ADDENDUM NO. 1 TO PROJECT NO. 44184

CONSTRUCTION WORK, HVAC WORK AND ELECTRICAL WORK

**PROVIDE VENTILATION, MAIN SCHOOL BUILDINGS
VARIOUS DOCCS FACILITIES**

March 7, 2013

SECTION 2
 SCALE: 1/2" = 1'-0"
 S202

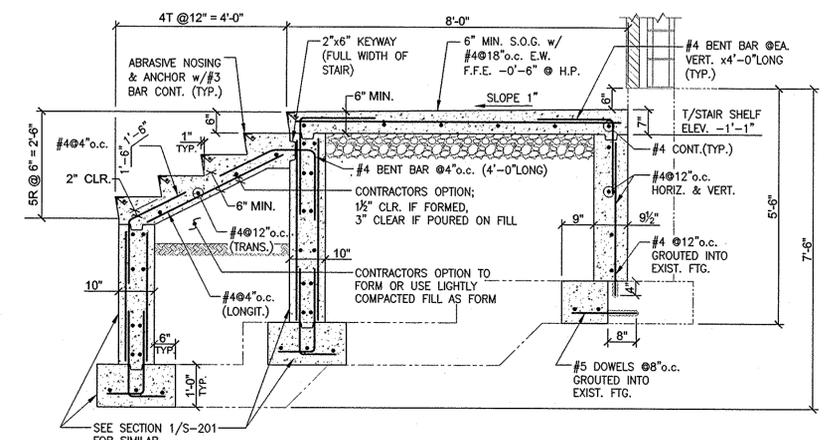
5. Drawing S-201:
 - a. SECTION 2/S201: Change “1/2” EXP. JOINT WITH TYPE 1B SEALANT” to read “1/2” EXP. JOINT WITH TYPE 1A SEALANT.”
 - b. Drawing S-202, noted “3/6/2013 ADDENDUM 1” accompany this Addendum and forms a part of the Contract Documents.
 - c. Replace detail “TYP. MASONRY WALL REINFORCEMENT ELEVATION” with the detail shown on drawing S-203 accompanying this Addendum.
 - d. Add detail “TYPICAL SLAB WALL EXPANSION JOINT” shown on drawing S-203 accompanying this Addendum.

SHEET TITLE: REVISED DETAIL
 FIRE ALARM
 ONE-LINE

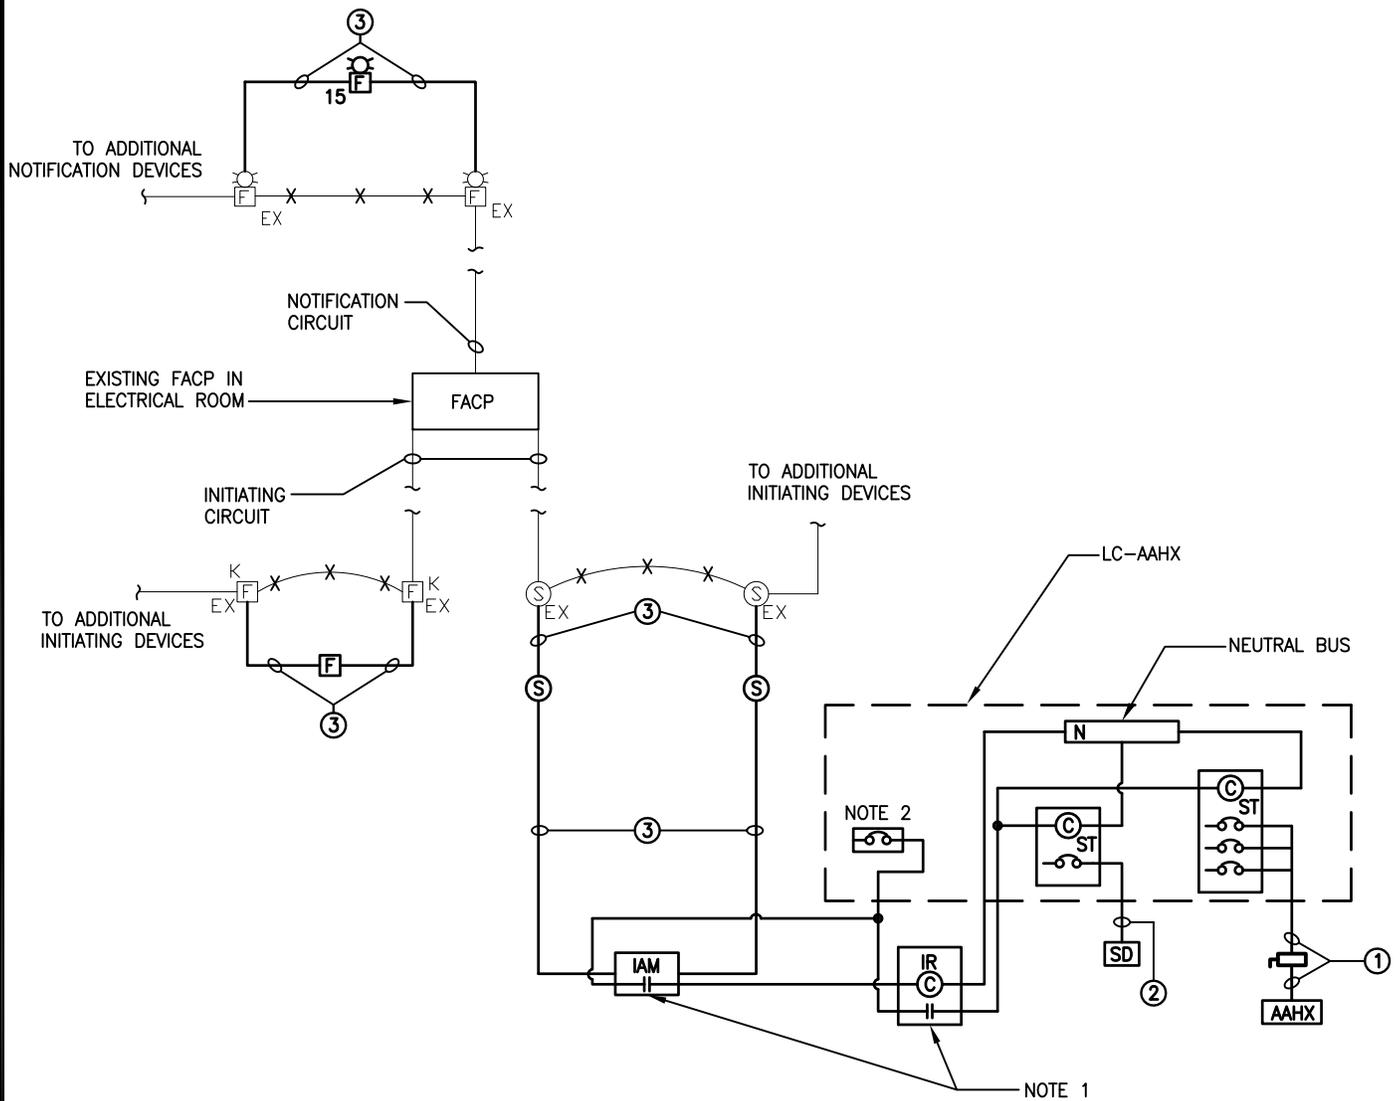
- Add leader, with text to read “NOTE 4 (TYP)”, to one symbol for AIR DUCT SMOKE SENSORS.
 - b. “FIRE ALARM ONE-LINE – BARE HILL CF BLDG. NO. 4”
 - Replace detail with detail on drawing E-116, noted “REVISED DETAIL FIRE ALARM ONE-LINE 3/6/2013”.

- Replace detail with detail on drawing E-116, noted “REVISED DETAIL FIRE ALARM ONE-LINE 3/6/2013”.
